# **Potomac Yard Design Advisory Committee Meeting (PYDAC)**

**Wednesday, July 25, 2012**

## Meeting Agenda

DATE: June 13, 2012  
TO: Potomac Yard Design Advisory Committee  
FROM: Planning Staff  
SUBJECT: Landbay G Amendments

COVER SHEET  
POTOMAC YARD  
LANDBAY J - MULTIFAMILY  
CONCEPTUAL PLAN

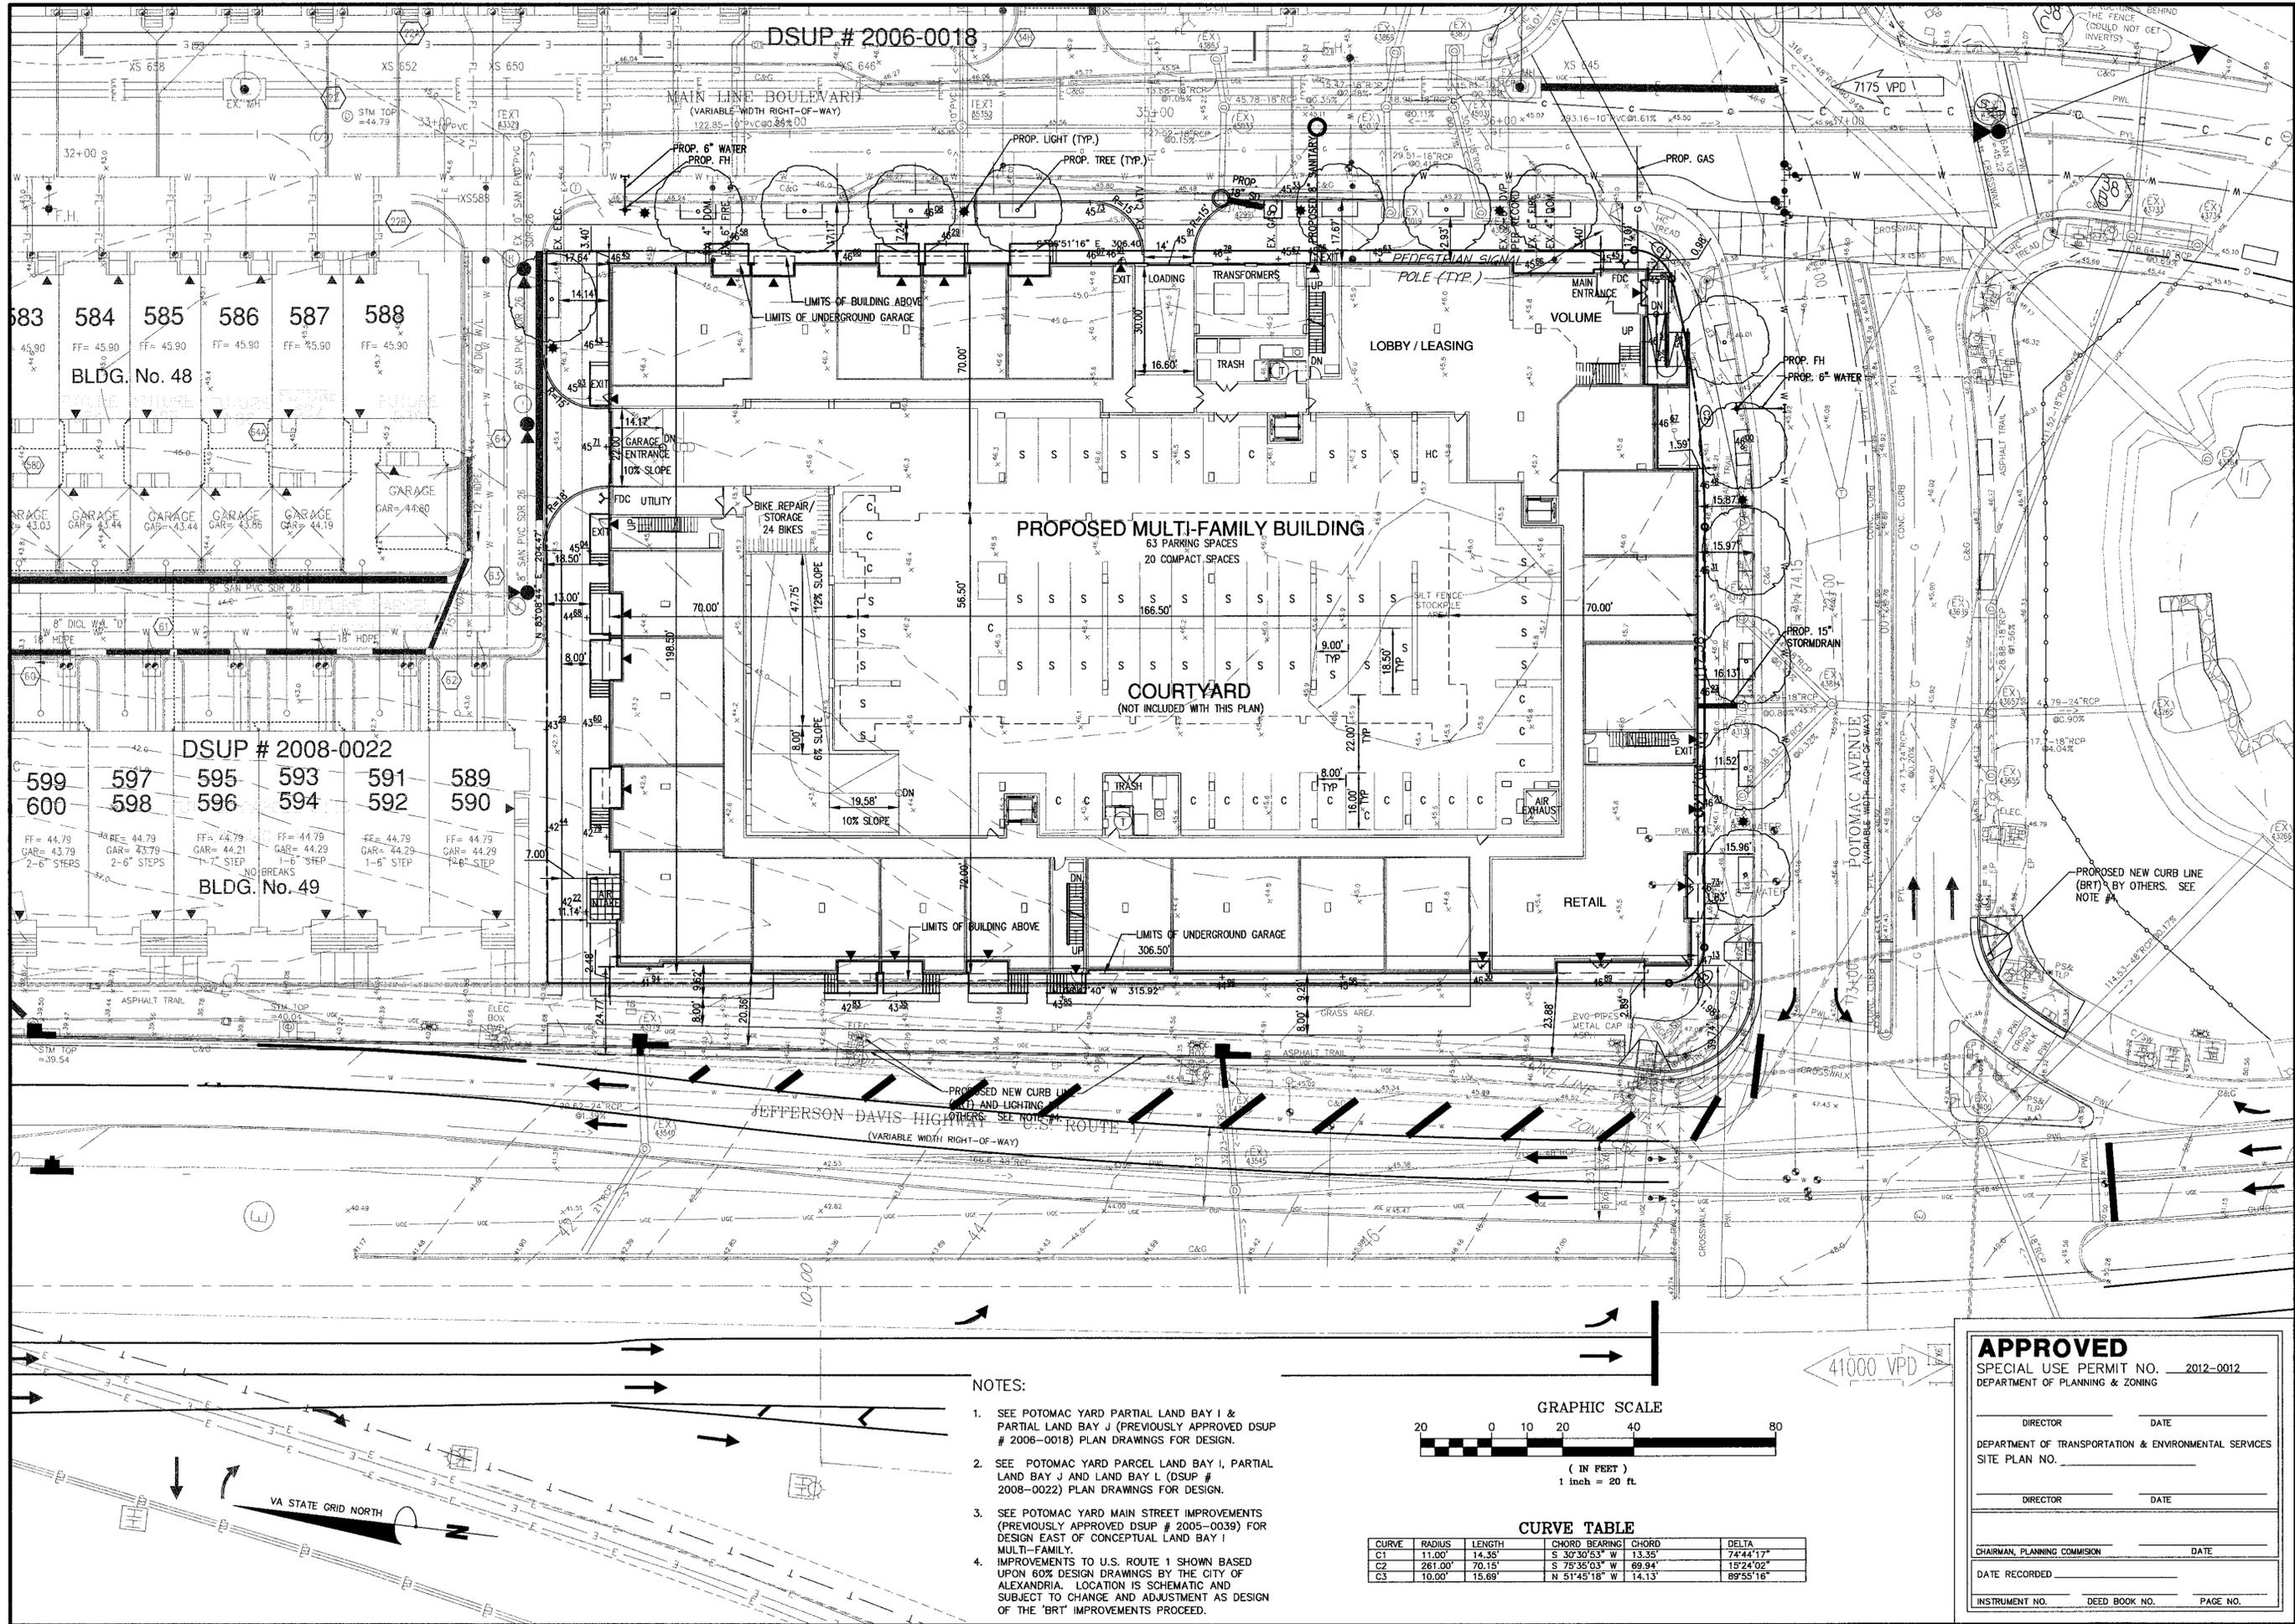
The overall site layout is generally consistent with the approved CDD Concept Plan and design guidelines. Two significant changes have been made since the previous review by the Committee. First, the retail space has been relocated from the corner of Main Line Boulevard and Potomac Avenue to the corner of Potomac Avenue and Route 1. This provides greater visibility for the future retail tenant since it will front Route 1 at a prominent location at the bottom of the bridge. Also, there will be a future BRT stop at this intersection, which provides additional patrons for the retail use. The main residential lobby has been relocated to the previous retail location, which will provide a more compatible use for the townhouses across Main Line Boulevard.

The second change is the location of the garage entrance. The previous concept plan had the garage entrance and loading space off Main Line Boulevard in the center of the block. In response to staff comments, the applicant has relocated the garage entrance to the alley along the north property line. This is consistent with the Design Guidelines goals for Main Line Boulevard to have as few curb cuts as possible and to locate garage entrances to the side or rear of buildings. The loading space will remain in the same location, but will include a door to minimize visibility. The sidewalk will continue flush across this driveway to create a continuous sidewalk along Main Line Boulevard.

CONCEPTUAL PLAN  
**POTOMAC YARD**  
LANDBAY J - MULTIFAMILY  
CONCEPTUAL PLAN

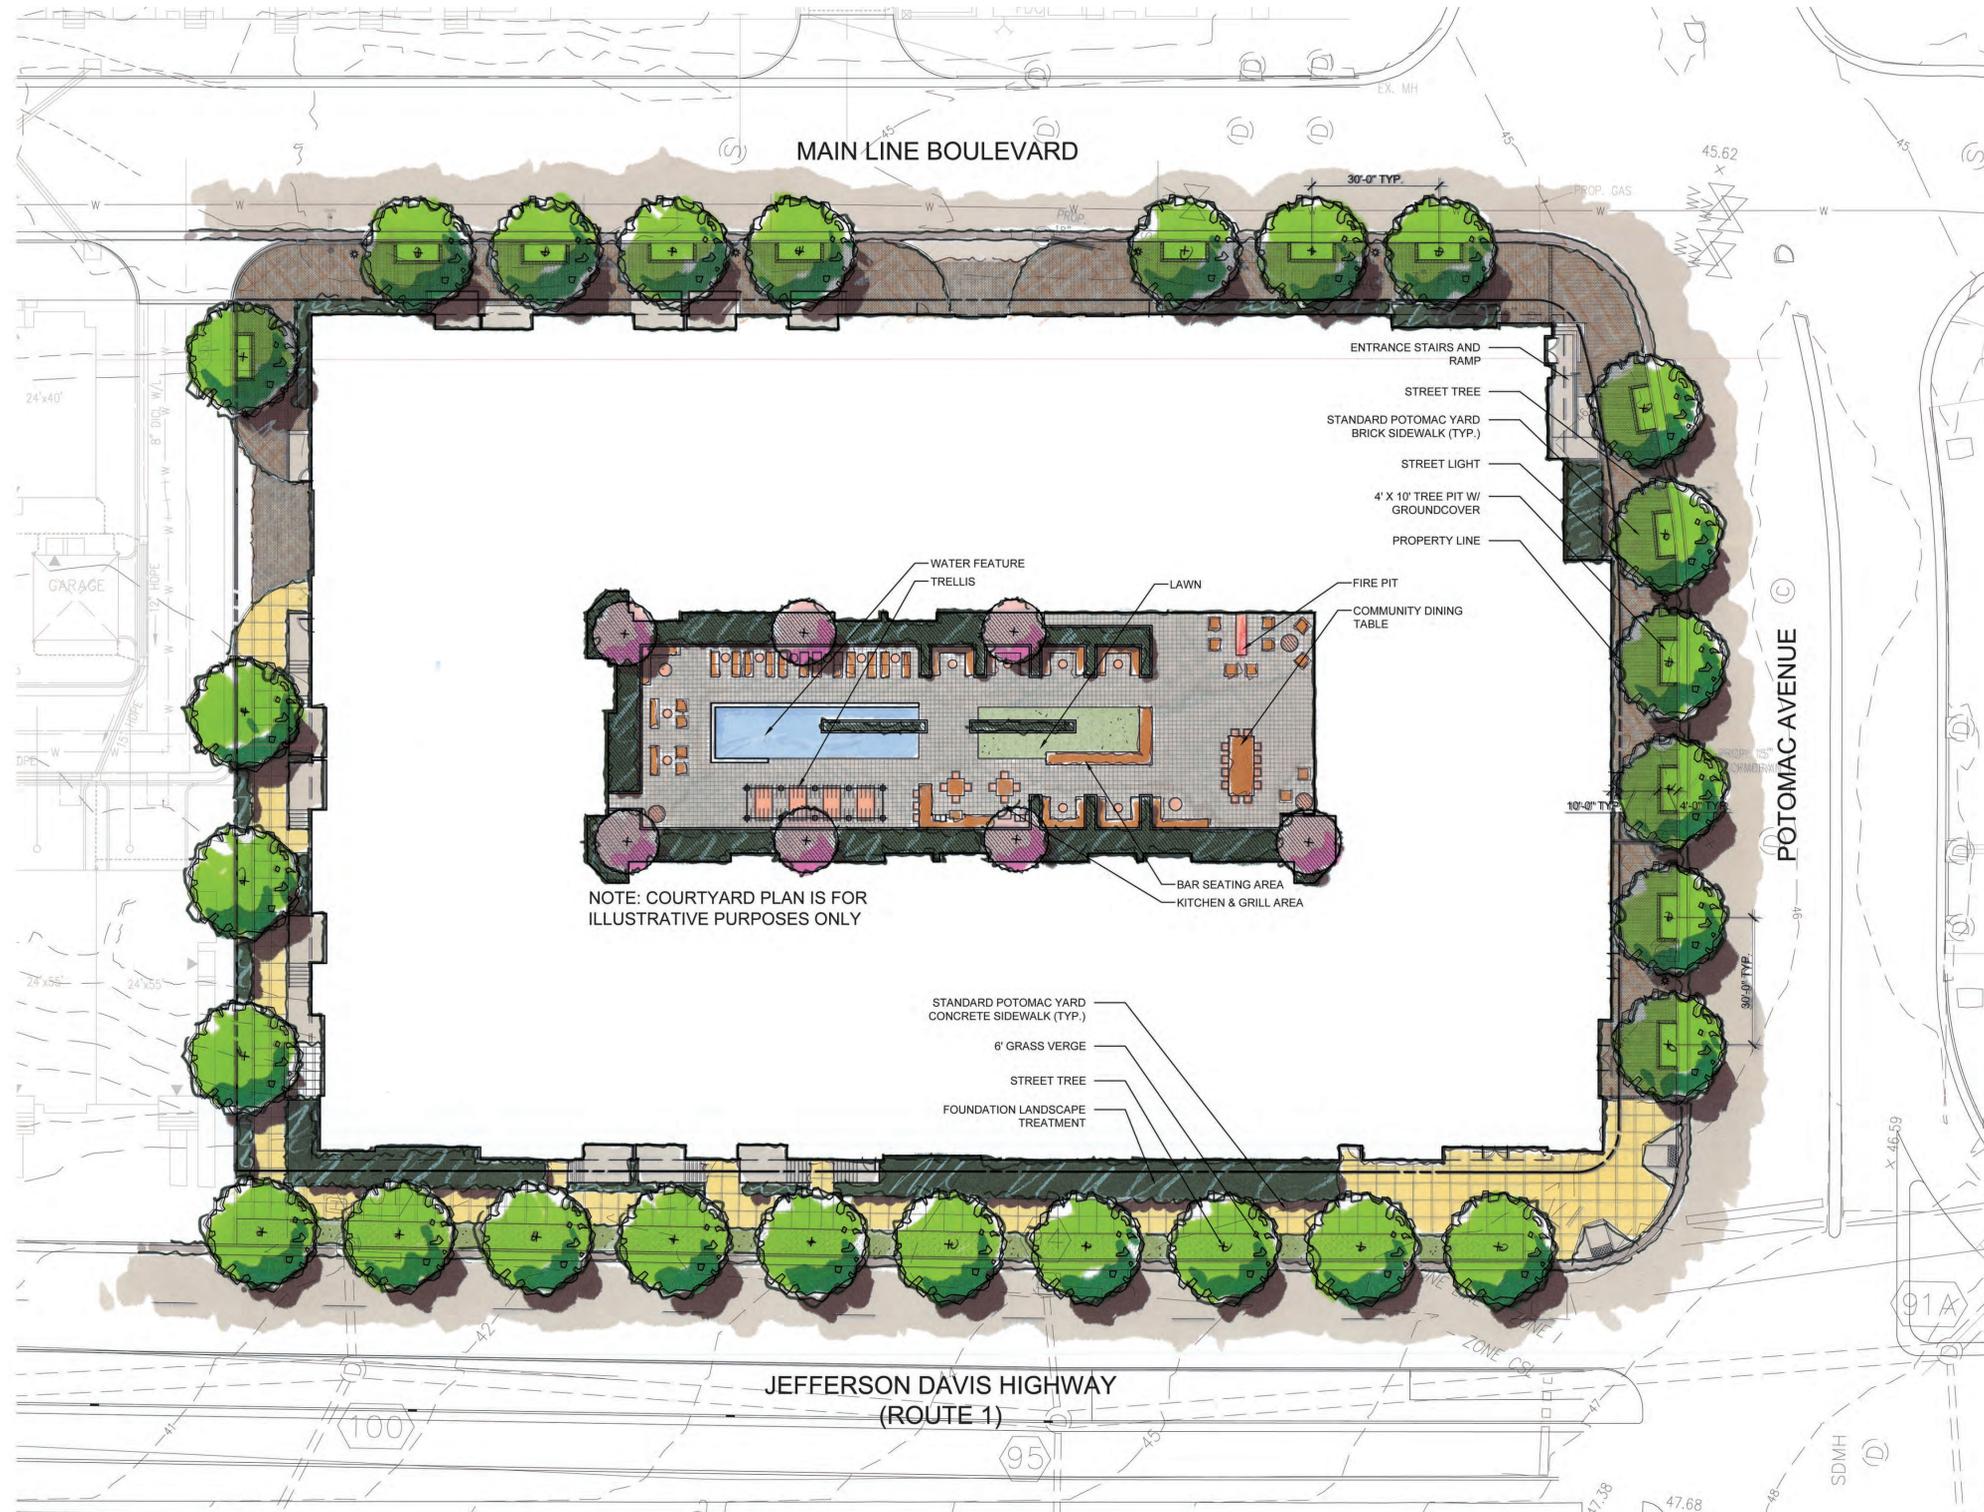
The building, which occupies almost all of the block, is approximately 300 feet long (north-south) and 200 feet wide (east-west). To minimize the perceived length of the building along Route 1 and Main Line Boulevard there is a building break provided by a change in materials, color, and patterns. The building materials are predominately brick, with metal used at the corner towers, and fiber cement panel used along portions of the upper stories. There are fewer units on the top floor due to density limitations which creates some change in height at the roof level. The applicant has arranged the units on this level so that the full fifth floor and taller portion of the building is at the south and west sides of the building. This gives more height to Route 1 and reduces the height along the north and east which is more compatible with the proposed townhouses. In response to Committee and staff comments, stoops have been added along Route 1, Main Line Boulevard, and the alley.

- Propose an alternate solution to the shingle roof along Main Line Boulevard and the alley. Since this is where the loft units are, the applicant could incorporate more glass to these upper levels.
- Minimize the number of balconies on the Potomac Avenue elevation and/or consider using a glass balcony railing or making these enclosed sunrooms.
- Provide more distinction between the two “buildings” through more glass in the southern portion, alternative masonry materials and colors, and different bay treatments.
- Use colored vinyl windows to match the surrounding material colors and provide further variation between the two “buildings”.
